CENTRAL PARK SOUTH JSP 25-33

Public hearing regarding JSP 25-33 Central Park South for Preliminary Site Plan, Wetland Permit, Woodland Permit and Storm Water Management Plan. The subject property is zoned RM-2 (High Density Multiple Family) and is approximately 6.6 acres. The applicant is proposing a multifamily development with 106 units in a single 5-story building.

Required Action

PRELIMINARY DEMOLITION PLAN & WETLAND IMPACT PLAN
Environmental engineers, Inc.
18200 WEST TEN MILE ROAD SOUTHFIELD, MICHIGAN 48075
PHONE: 248/424-0810 FAX: 248/424-0854

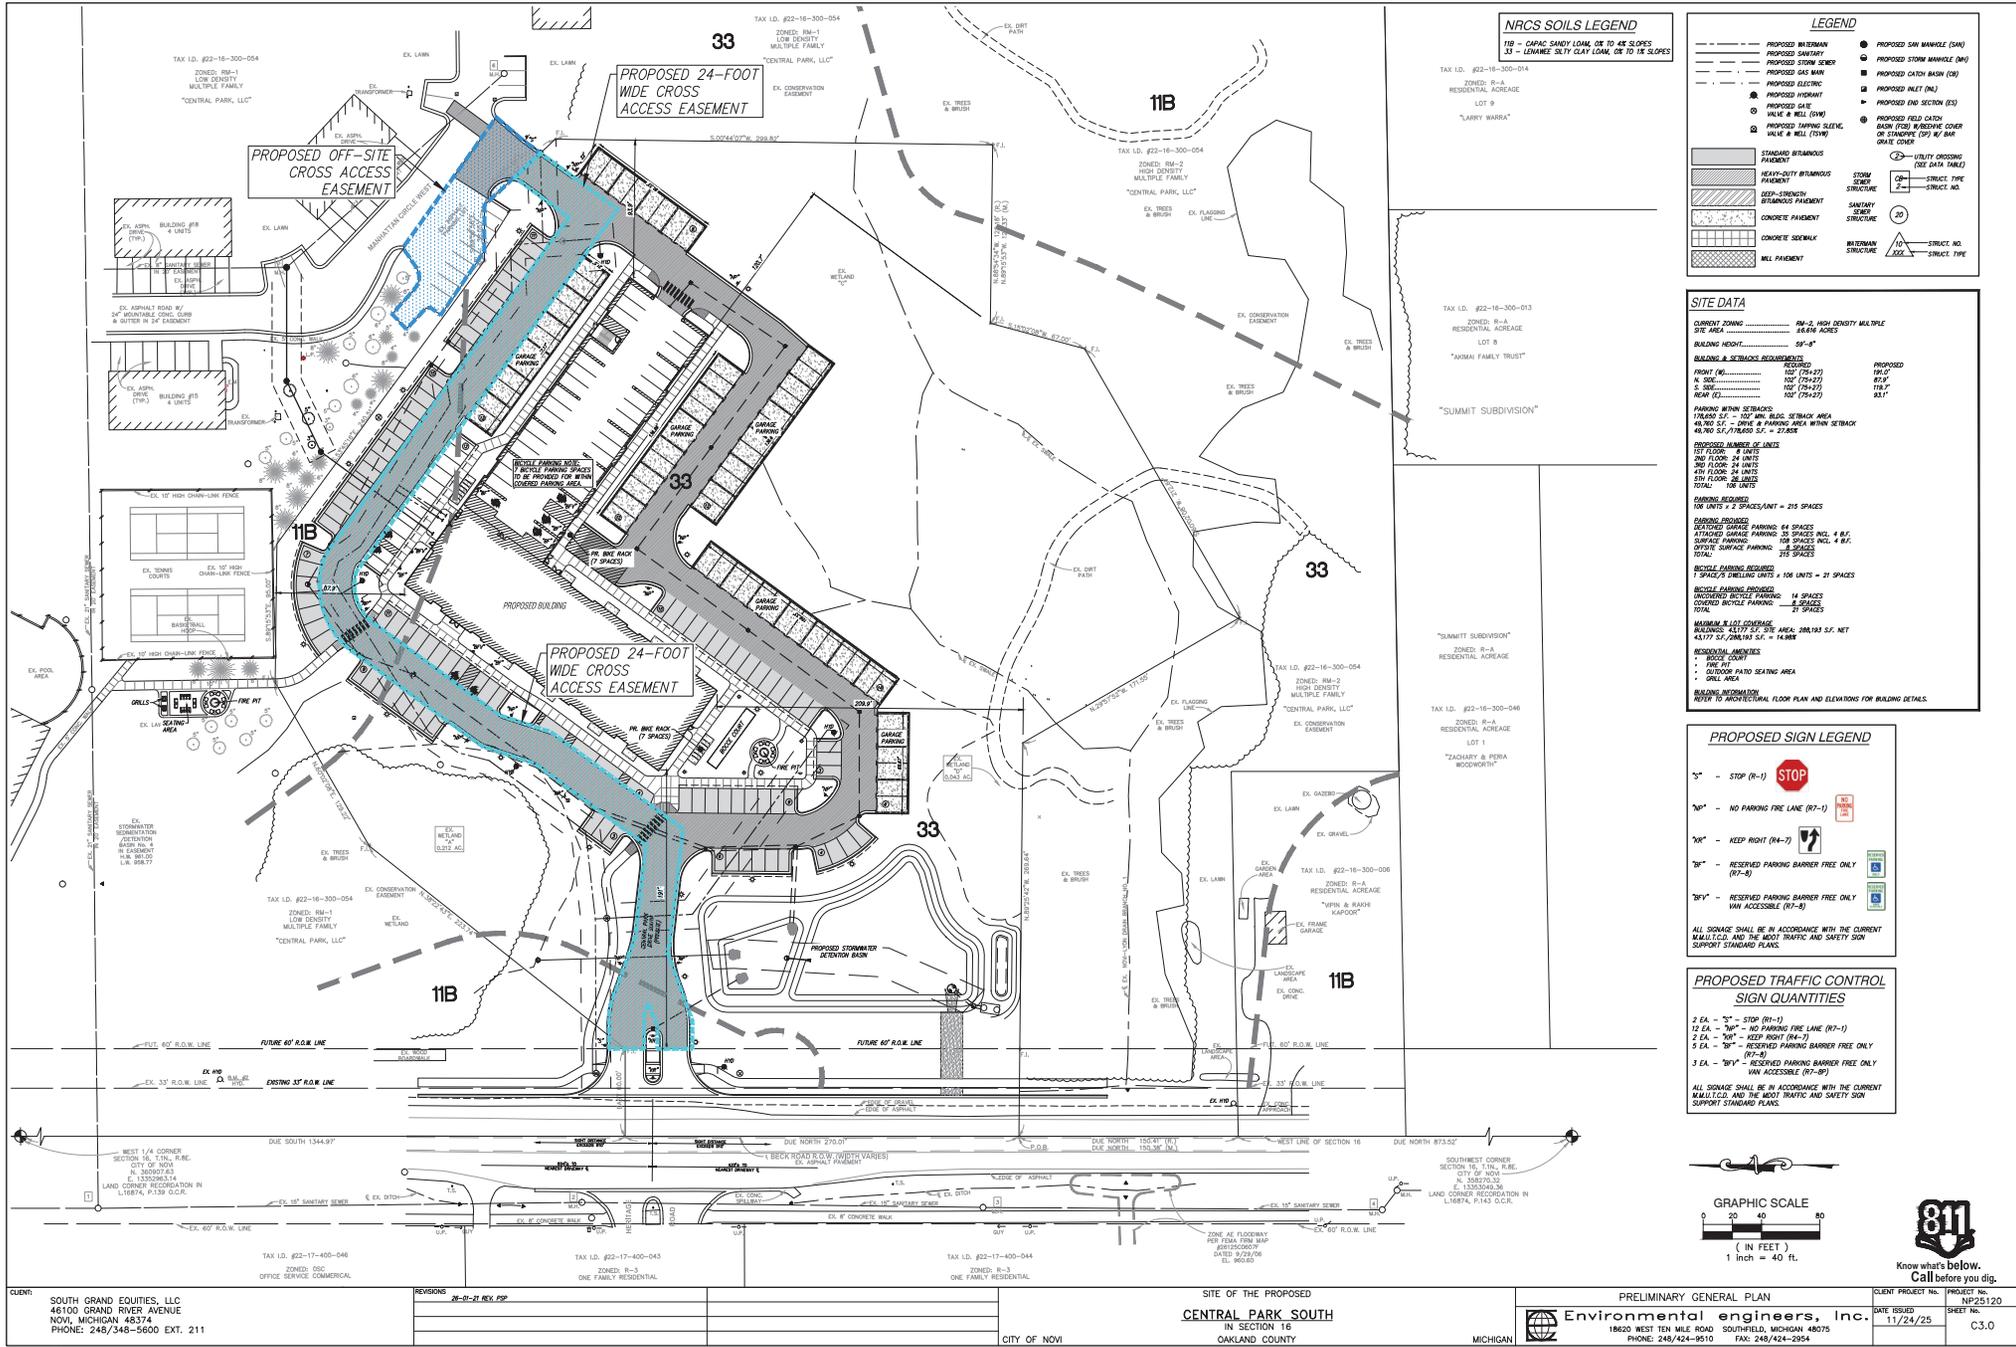
7. Limits of Disturbance: It appears Sheet C2.1 indicates a Limit of Disturbance that does not reflect what is shown on the Grading plan, sheet C5.0. On Sheet C6.1, the location of the silt fence also appears to be in a location that would not allow the grading shown on sheet C5.0. Address all inconsistencies on the Final Site Plan submittal.

1. The full extent of wetlands to be impacted is not depicted on Sheet C2.1. The provided concept plan and grading sheets shows grading extending beyond the limits of disturbance.

2. Woodland replacement calculations are not provided.
[Woodland Replacement calculations are provided on sheet C7.6. These calculations are based on the assumption that 339 surplus tree credits were provided in 2001 as part of the Central Park Estates development in preparation for this future development. Confirmation and documentation will be provided in support of this assumption prior to final approval.](#)
4. Please clearly show the tree protection fencing limits on the demolition plan, per the actual tree driplines, not the edges of the tree symbols, and add the city tree protection fence detail to the sheet.
[Tree protection fencing is now shown on the demolition plan sheet C2.1](#)

Stormwater Management Calculations
Environmental Engineers, Inc.
1820 WEST TEN MILE ROAD SOUTHFIELD, MICHIGAN 48075
PHONE: 248/624-8510 FAX: 248/624-8554

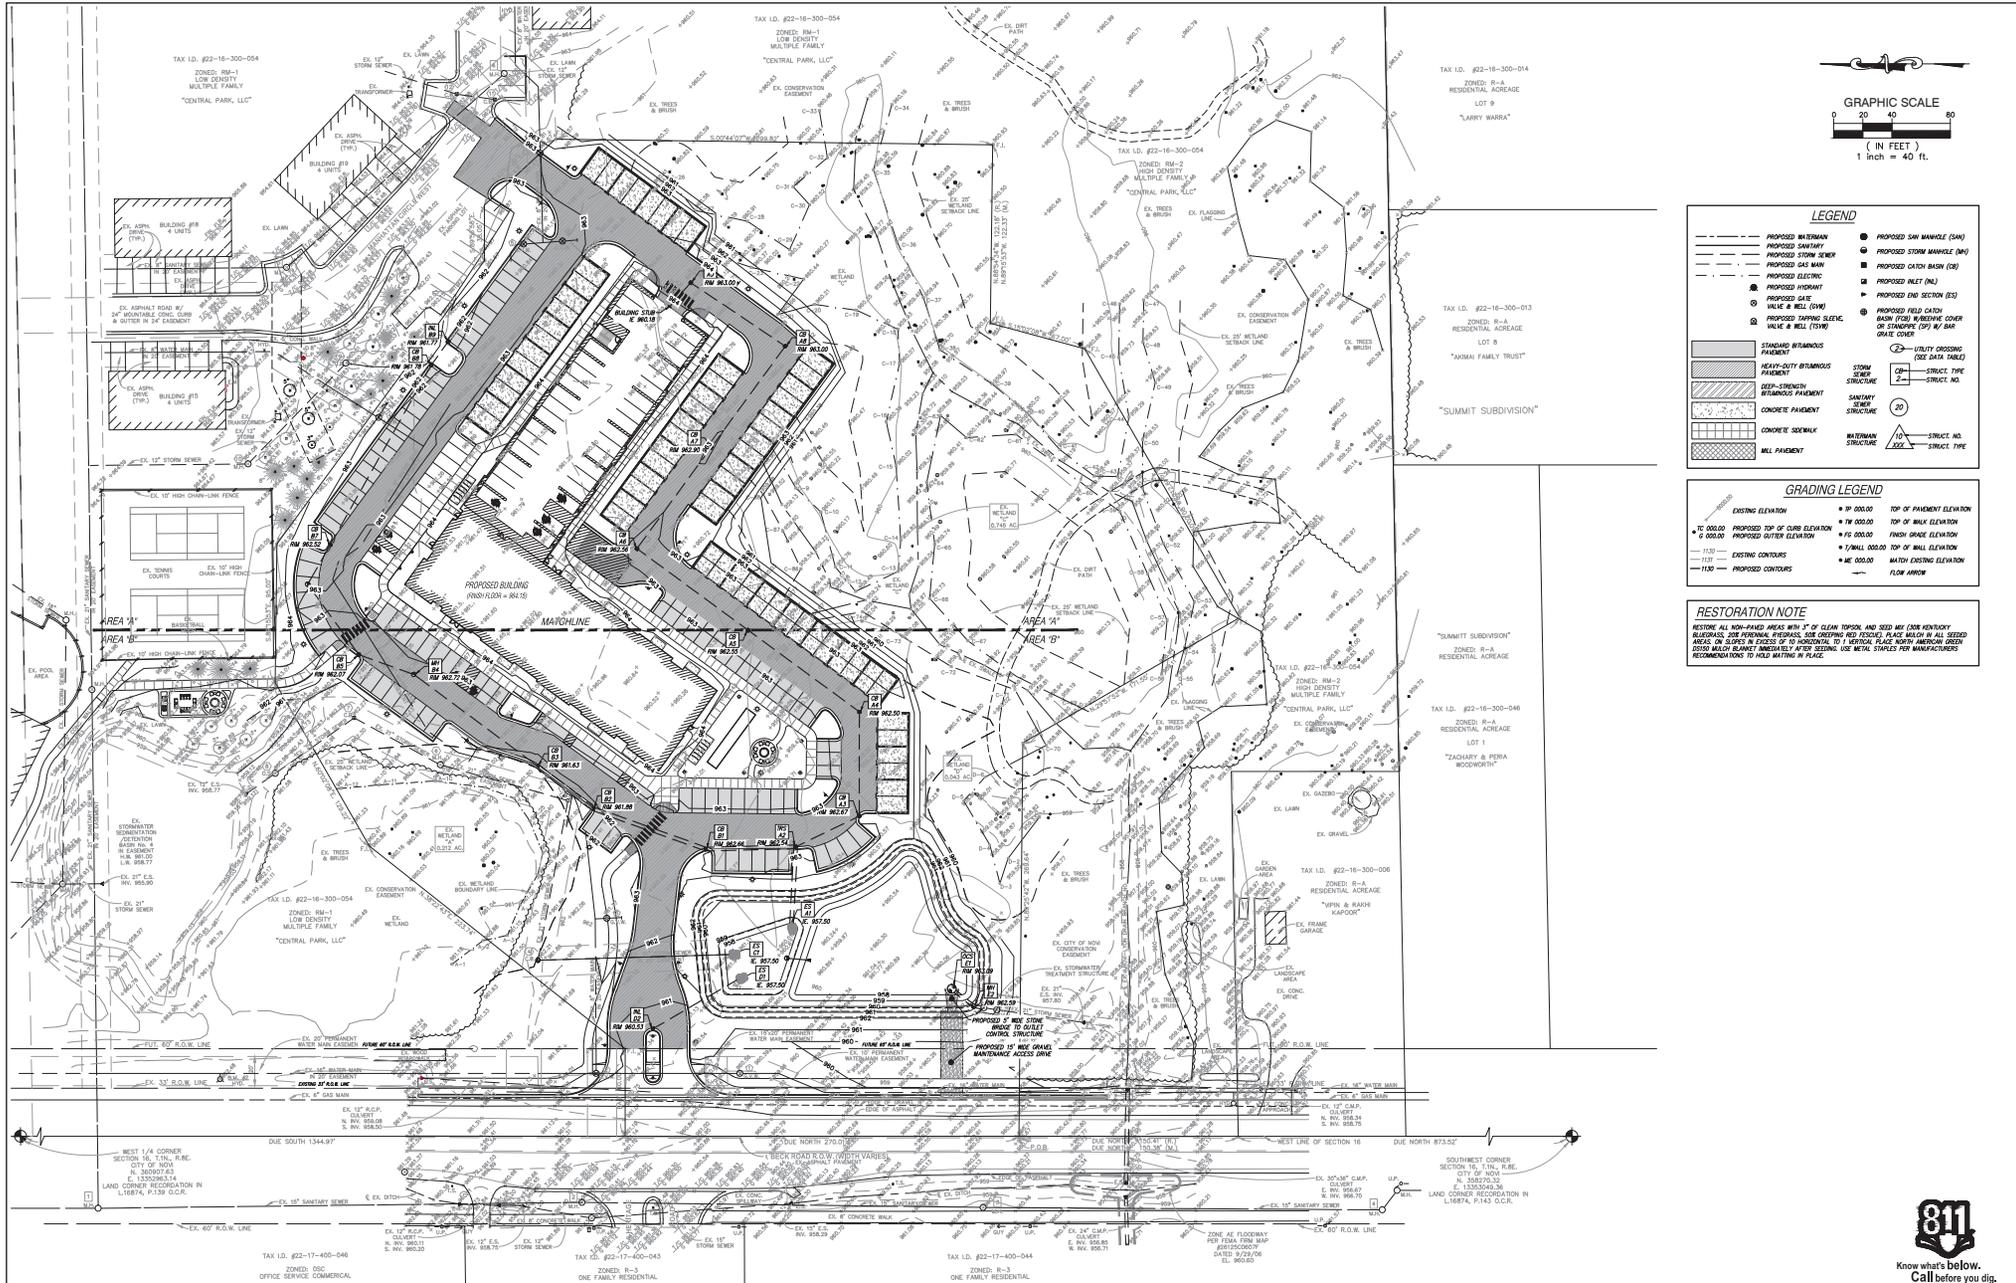
8. Woodland Impact: The plan shows the removal of 138 regulated woodland trees. **However, the grading plan, sheet C5.0, indicates additional trees' Critical Root Zones will likely be impacted by the contouring on the south and east side of the site. Those impacted trees will need to be added to the total woodland impact calculations. As shown by the applicant's plan (Sheet C3.5) and narrative, 339 woodland replacement credits for the Beck House development (previously proposed for the subject property) were proposed and approved to be planted on the Central Park Estates site in 2001. Since the current number of woodland replacements is approximately 260 (with some additional credits likely from impacts shown on the grading plan), it appears all woodland replacements credits have been fulfilled for this project.**

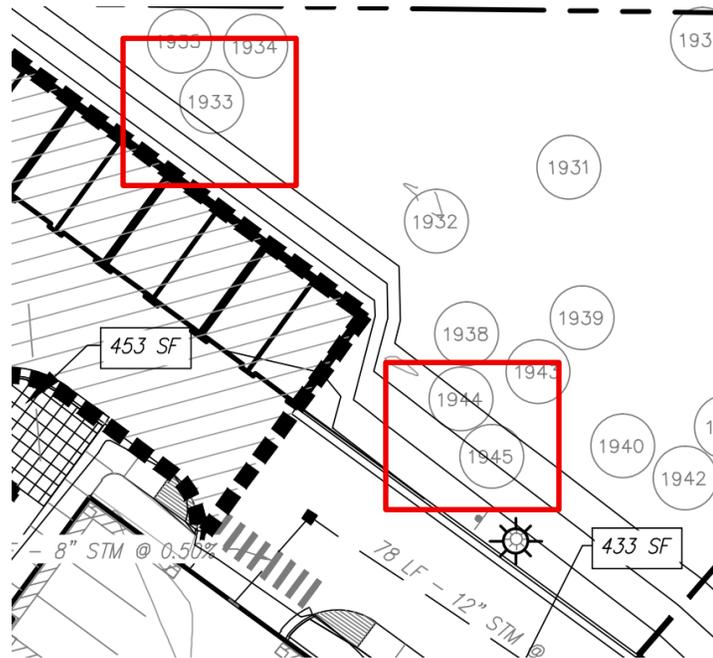
Required edit: the applicant has shown grading extending past the limits of disturbance. This will likely affect the root zone, or require the removal of some trees not listed for removal. For example, trees 1933, 1944, 1945, and 1973 (not an exhaustive list) all show grading either partially or fully encompassing the tree. The removal calculations should be updated to show these impacts.
